# URBAN DESIGN COMMITTEE

## URBAN DESIGN COMMITTEE STAFF REPORT

## URBAN DESIGN COMMITTEE STAFF REPORT

## URBAN DESIGN COMMITTEE STAFF REPORT

**GROUND LEVEL PLAN**  
1/8" = 1' 0"

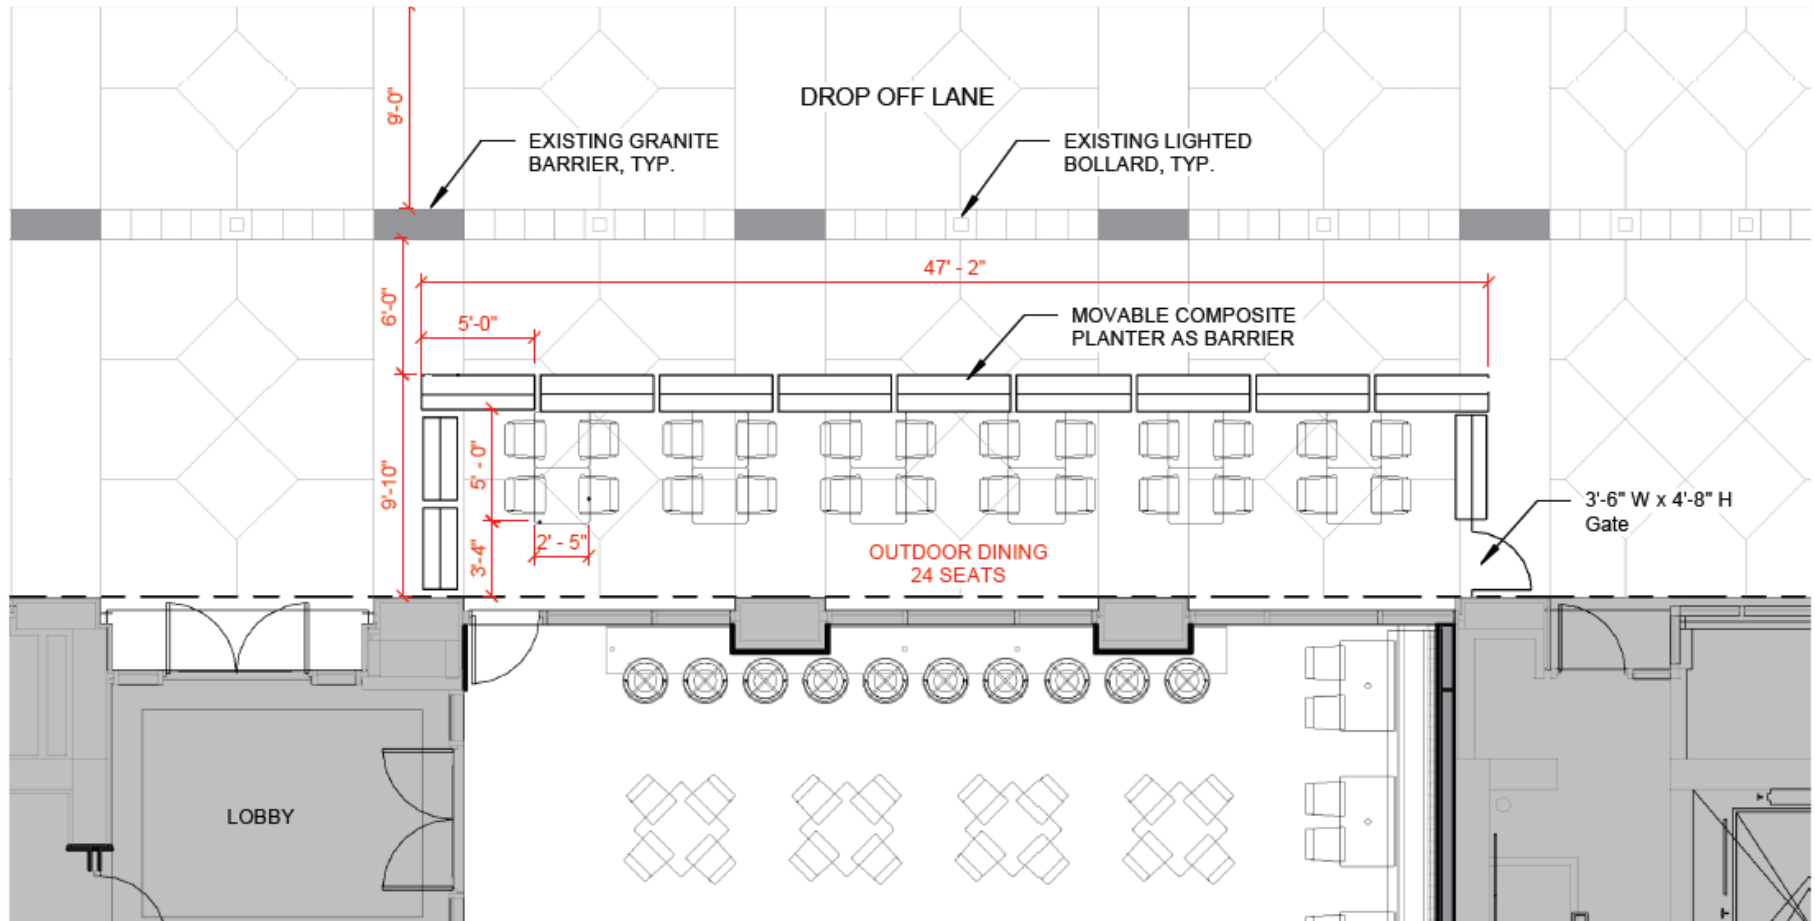
*The sidewalk space available for movement abutting the building is approximately 15'-10" wide. Installing a 9'-10" wide fencing would leave around 6' of passageway for pedestrian movement spanning the length of the sidewalk café. (diagram below)*

# ATTACHMENT B – Site Plan

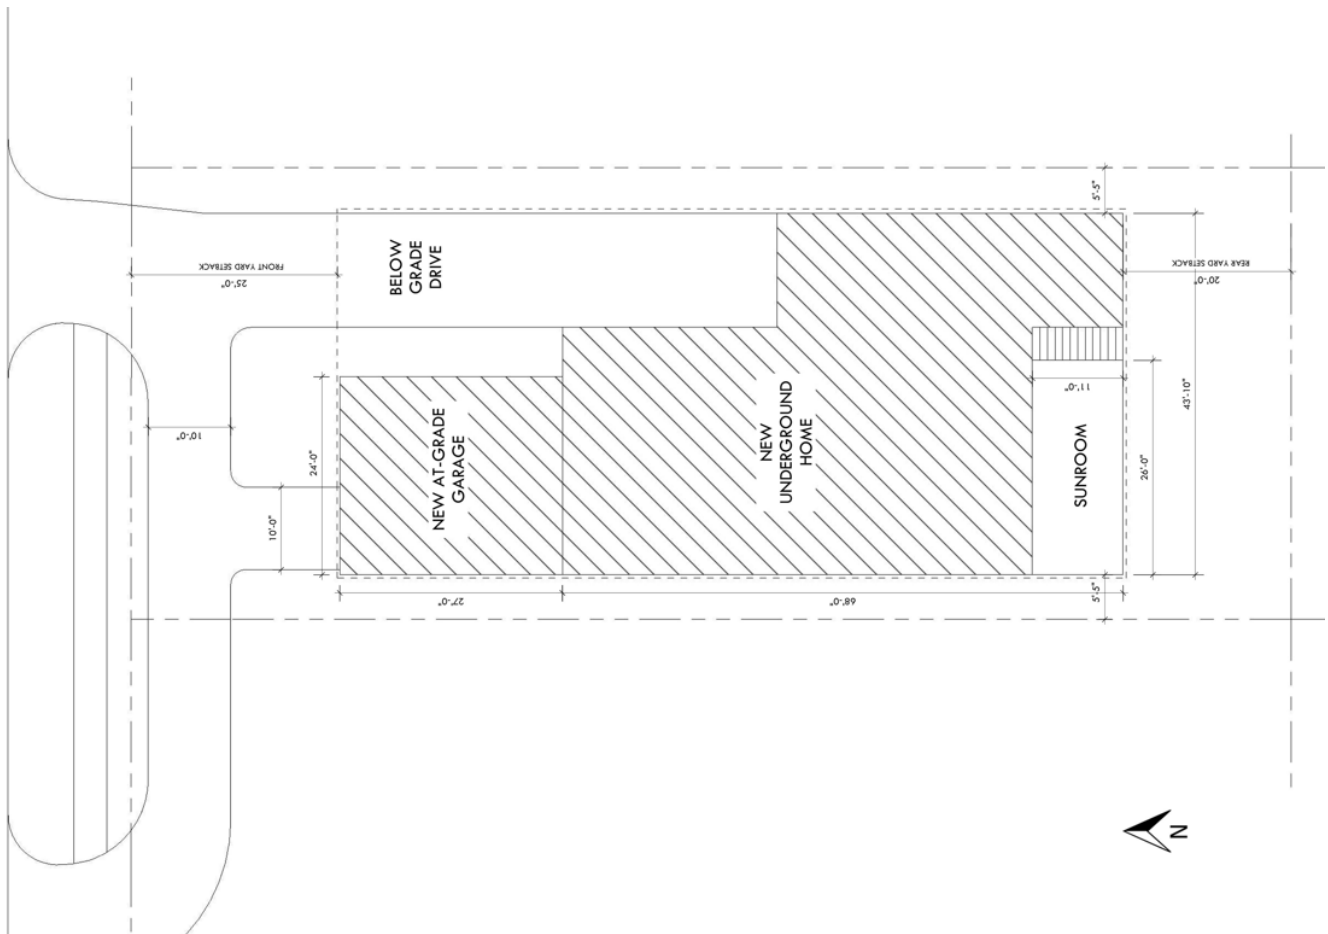
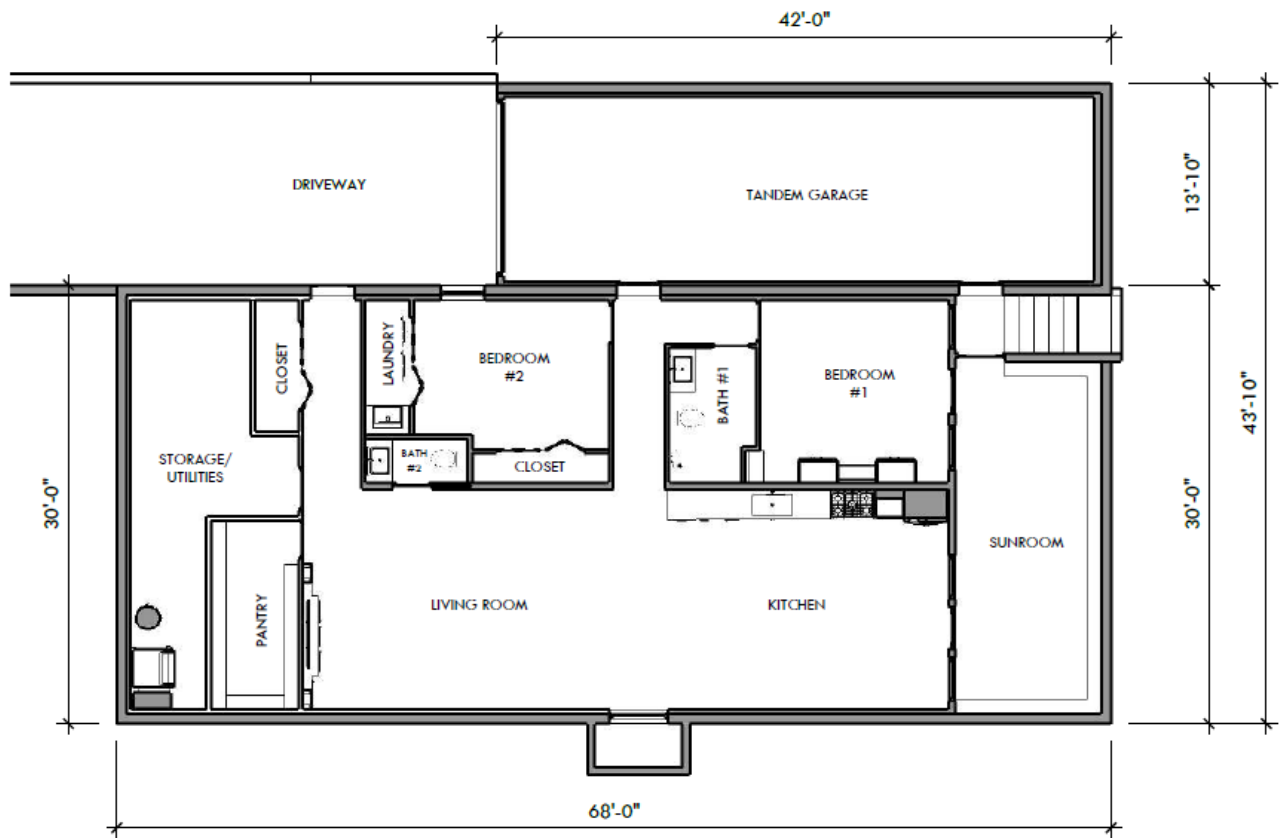
**Compatibility per Staff Analysis:** *No existing trees are being cut down for this construction. However, the proposal shows a tree that would be planted between the driveway and the sidewalk, to blend with the existing pattern of trees on the block.*

- In the site plan, the garage is set back 25' from the front lot line, as required in the zoning code. However, it appears to be closer to the property line than in the neighboring properties (27,28' or more than 30' in some cases). Staff would encourage the applicant to have the structure on the same plane as the adjacent houses, or as close as possible to align with the front face of the existing buildings.

## NORTH ELEVATION

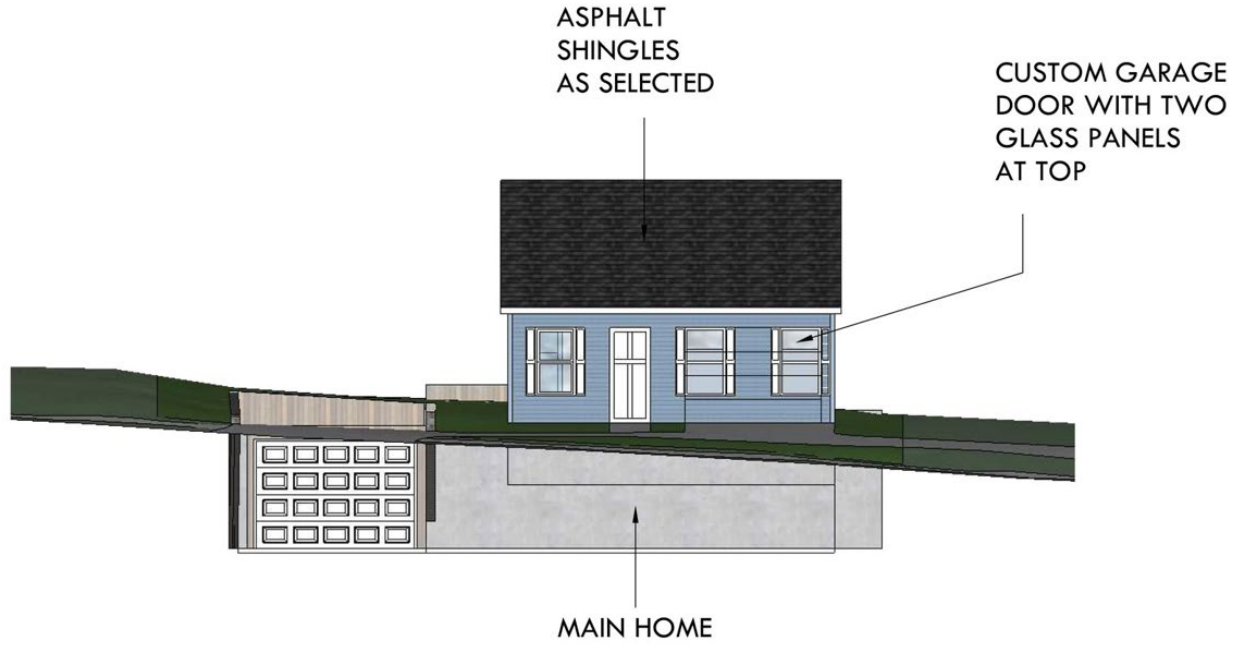
*Garage doors do not count as openings. Apart from the garage door, the structure has a door, and a double-hung window fronting the street.*

*The top panel of the garage door would have two plexiglass panels, and the rest of the garage door would be painted to look like windows and shutters.*

*Painting windows and shutters on the garage door will require maintenance and over time could be painted over. Painting faux features on the garage should be considered by the Commissioners.*
